From: Bob Clark-Riddell <briddell@pangeaenv.com>
Sent: Wednesday, November 18, 2015 4:47 PM
To: Wickham, Jerry, Env. Health
Subject: RE: 1230 14th Street Excavation - Urgent Well Destruction
Attachments: Draft Excavation Plan 11-18-15.pdf

Draft Excavation Plan
11/18/15

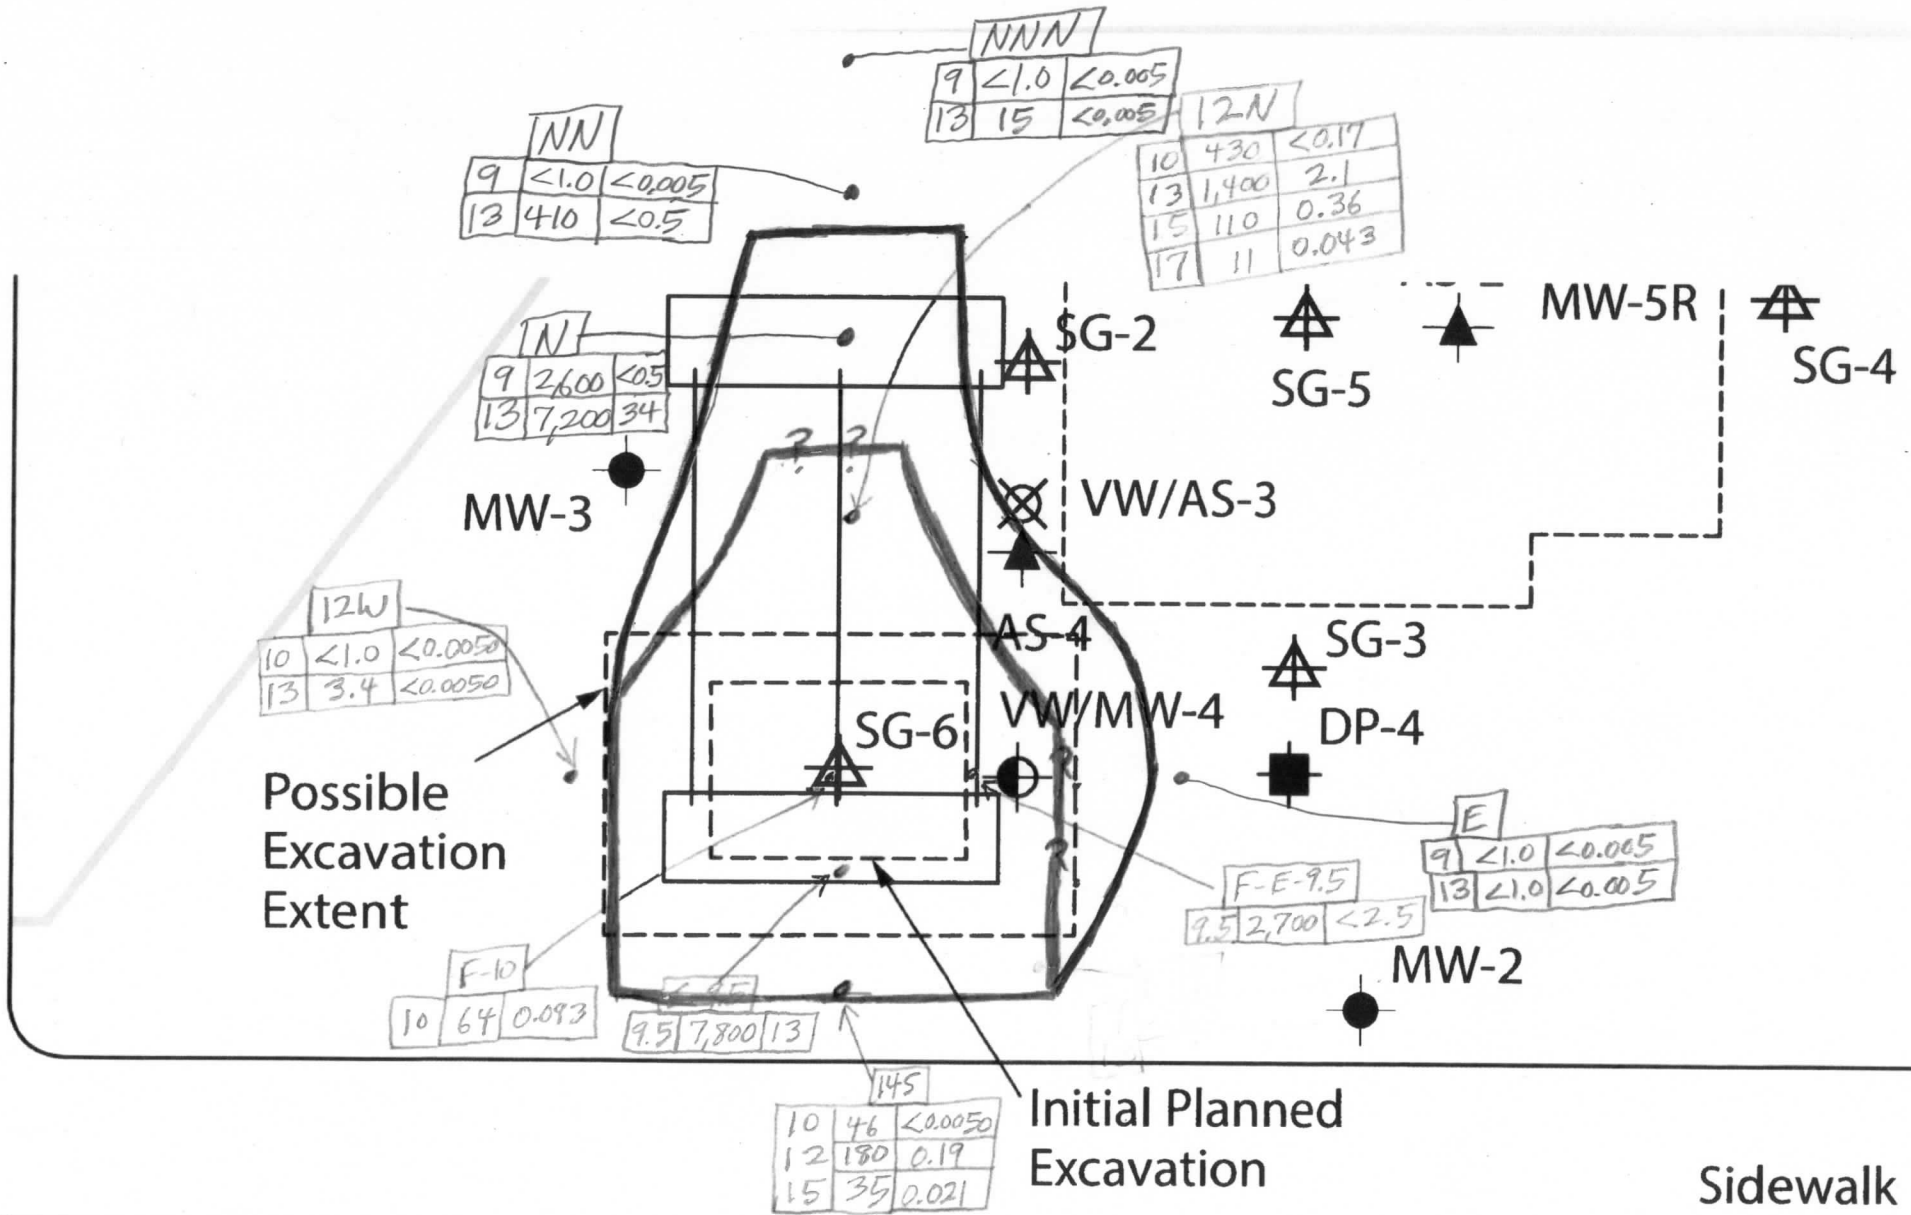
Per your request Pangea coordinated additional delineation north and east of the excavation. As shown on the attached map, the planned excavation will be expanded to the north to meet the revised cleanup goal. The excavation will be extended north about 10 feet and east about 5 ft. Note that the first northern test pit found 34 mg/kg benzene at 13', much higher than prior maximum benzene. This impact will now be removed also.

Based on the information you have presented, it appears that the proposed excavation to the north may be sufficient provided that confirmation soil samples collected at the completion of excavation to the north do not exceed the modified cleanup goals. In addition to the deeper soil samples collected at 10 feet and greater, please collect one confirmation sample between 3 to 5 feet bgs and one soil sample between 6 and 10 feet bgs from the northern wall for confirmation.

I did not see sidewall results from the eastern sidewall, only a floor sample apparently from 9.5 feet bgs. Therefore, it is not clear whether the excavation is sufficient to the east. Further delineation using borings or exploratory trenching to the east may be appropriate. For the eastern, southern, and western sidewalls, please include one soil confirmation sample from approximately 3 to 5 feet bgs and one confirmation soil sample between 6 and 10 feet bgs to demonstrate that shallow soils do not pose a risk and a bioattenuation zone exists for soil vapor.

Based on field observations and analytical results from samples collected during exploratory trenching last week, Pangea prepared the attached draft figure showing our tentative extent of excavation. The planned depth of the excavation is approximately 14 ft. For shoring, we will install a slurry wall adjacent the sidewalk and southern boundary on Tuesday. Excavation and offhaul will be Tuesday, Wed and Thurs. Our goal is to complete the excavation by Thursday this week, and backfill up to 5 ft depth on Friday.

This tentative extent is based on cleanup to revised screening levels from those in the approved workplan. Rather than more conservative Final ESLs in the workplan, Pangea proposes using the ESLs protective of human health of 0.74 mg/Kg benzene and 770 mg/Kg TPHg for residential site use (the anticipated future site use within a residential neighborhood). These screening levels are summarized below.

Question: As shown on the attached figure, contamination has been delineated to the proposed revised screening level to the south and west. Additional delineation to the north and east can be performed tomorrow if necessary. Otherwise, we can perform compliance sampling along the excavation boundary but we would not plan to overexcavate beyond the boundary at a later date. Would you like additional borings or exploratory trenching to the north and east for further delineation on Tuesday, or do you think we would have performed sufficient secondary source removal?
